**VILLAGE OF DOWNERS GROVE**  
 Report to the Village

<b>SUBJECT:</b>	<b>SUBMITTED BY:</b>
2001 63rd Street - Planned Unit Development Amendment, Special Use and Plat of Subdivision	Stan Popovich, AICP Director of Community Development

**VILLAGE OF DOWNERS GROVE  
REPORT FOR THE PLAN COMMISSION  
FEBRUARY 5, 2018 AGENDA**

<b>SUBJECT:</b>	<b>TYPE:</b>	<b>SUBMITTED BY:</b>
17-PLC-0041 2001 63 <sup>rd</sup> Street	PUD Amendment, Special Use and Plat of Subdivision	Rebecca Leitschuh, AICP Senior Planner

EAST ELEVATION

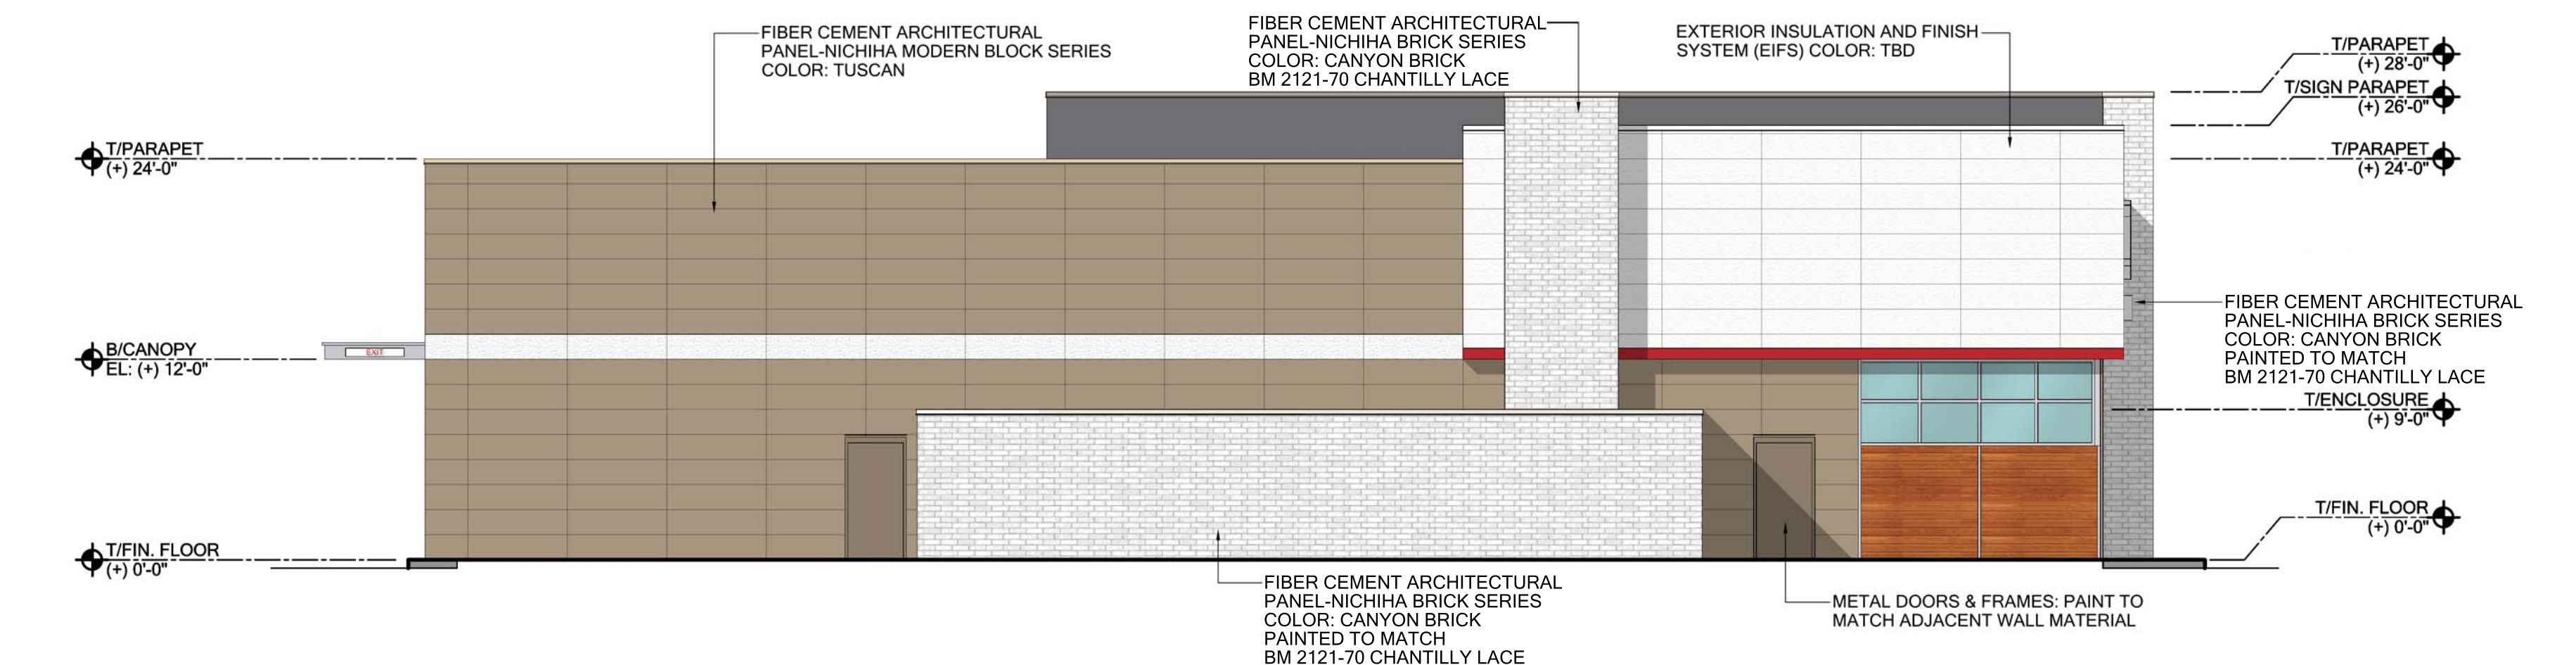
Staff recommends that condition #6, which requires the building design feature be extended across the entire length of the roof-line facing Woodward Avenue, remain. Staff believes the extended design feature creates a more attractive facade facing Woodward Avenue.

The Woodward Avenue (east) elevation continues to wrap the corner with wood panels, windows, and the white EIFS overhang. Staff requests a condition be made to extend the EIFS design element across the entire length of the eastern wall so as to bring greater design detail to the east elevation. A vertical pier, identical to the one on the western elevation, intersects the horizontal planes. The dumpster enclosure, while in a street yard, is designed to complement the building, incorporating the same fiber cement panel system.

EAST ELEVATION

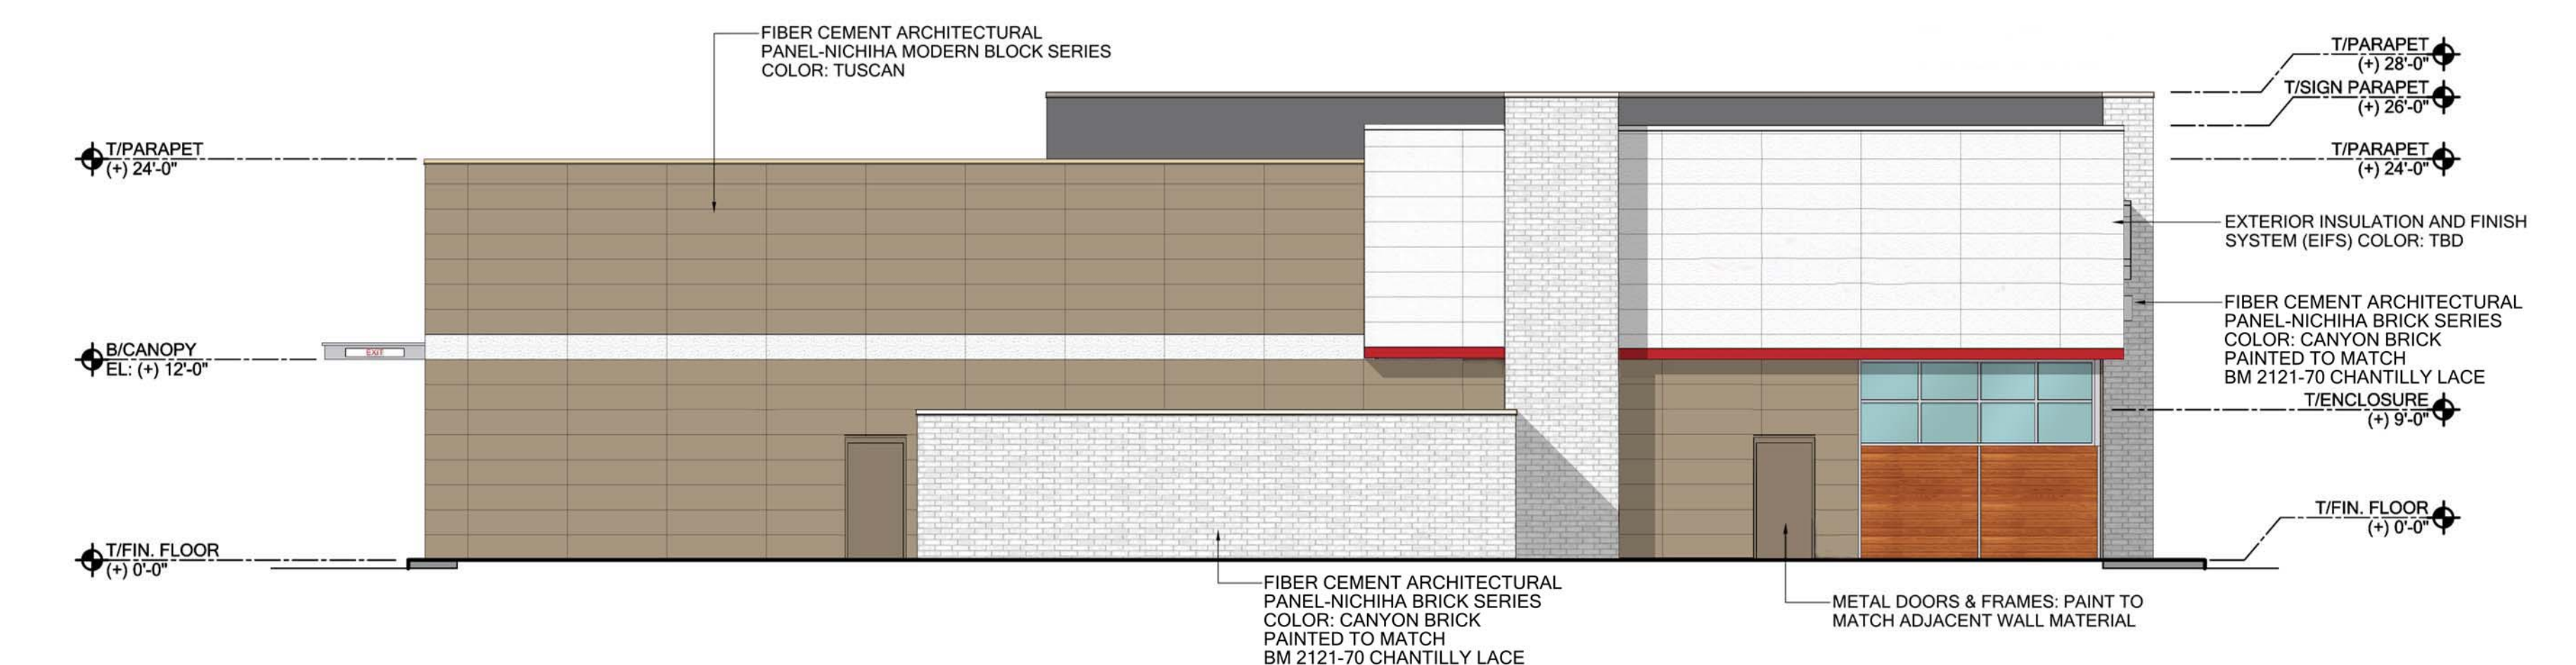
Revised east elevation
